**SUBJECT:** **ASR Site Planning Review**  
**4629 Sunnyside Road SE**  
**20-110194-RP (Class 2 Site Plan Review)**  
**Project Number 719000**

This memorandum is in response to the Planning Review Checklist, dated July 13, 2020, requesting additional information. The following summarizes a response to each item.

**TF-C-5**

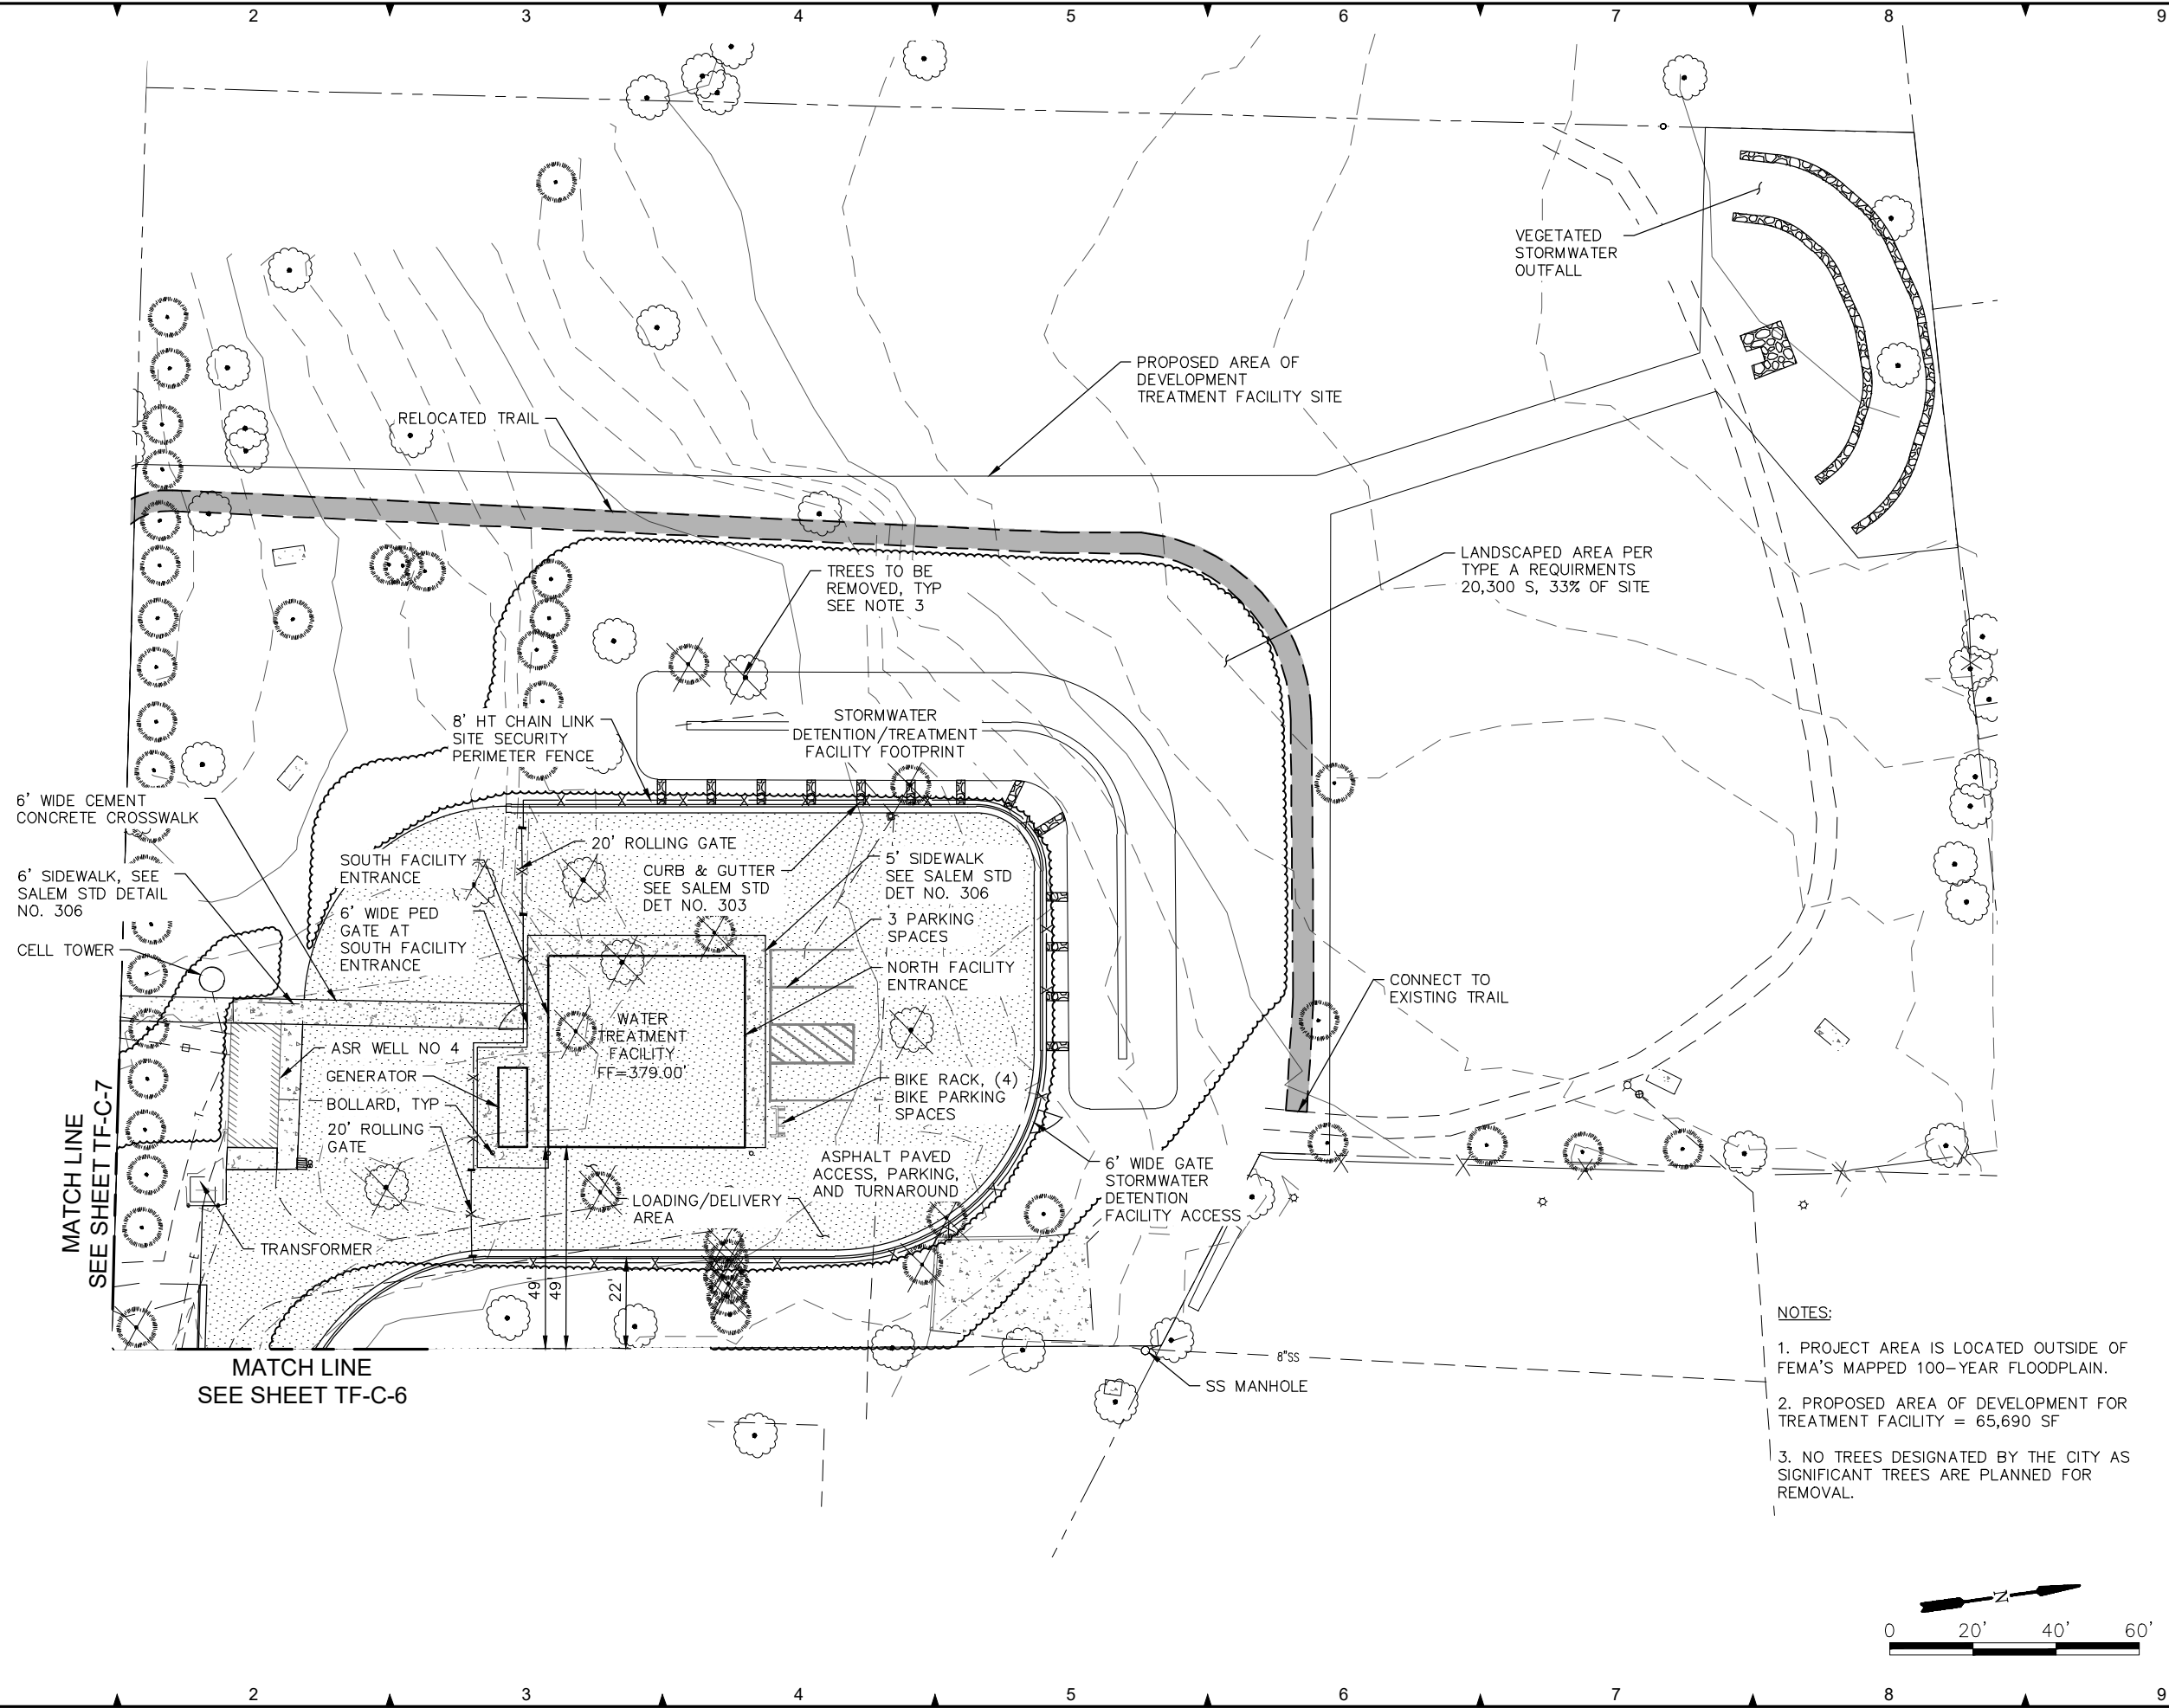
<p>SRC 806.060(a) and  (b) – Off-Street  Parking – Bicycle</p>	<p>SRC 806.060(a) provides that bicycle parking located outside a building shall be located within a convenient distance</p>	<p>See sheet TF-C-5. The project will provide four bicycle parking spaces within 50 feet of the north water</p>

Parking Development Standards	<p>of, and be clearly visible from, the primary building entrance. In no event shall bicycle parking be located more than 50 feet from the primary building entrance, as measured along a direct pedestrian access route.</p> <p>In addition, SRC 806.060(b) provides that bicycle parking areas shall have direct and accessible access to the public right-of-way and the primary building entrance that is free of obstructions and any barriers, such as curbs or stairs, which would require users to lift their bikes in order to access the bicycle parking area.</p> <p>The proposed bicycle parking location does not appear to comply with SRC 806.060(a) or (b).</p>	<p>treatment facility building entrance for users of the building.</p> <p>Bicycle parking spaces will be designed in conformance with the standards of Section 806.060 – Bicycle Parking Development Standards. People accessing the water treatment facility by bicycle would have a route unobstructed by curbs or stairs. Cyclists would need to open the gate of the fence to access the bicycle rack, as access to the water treatment facility would be limited to City staff and other authorized personnel.</p>
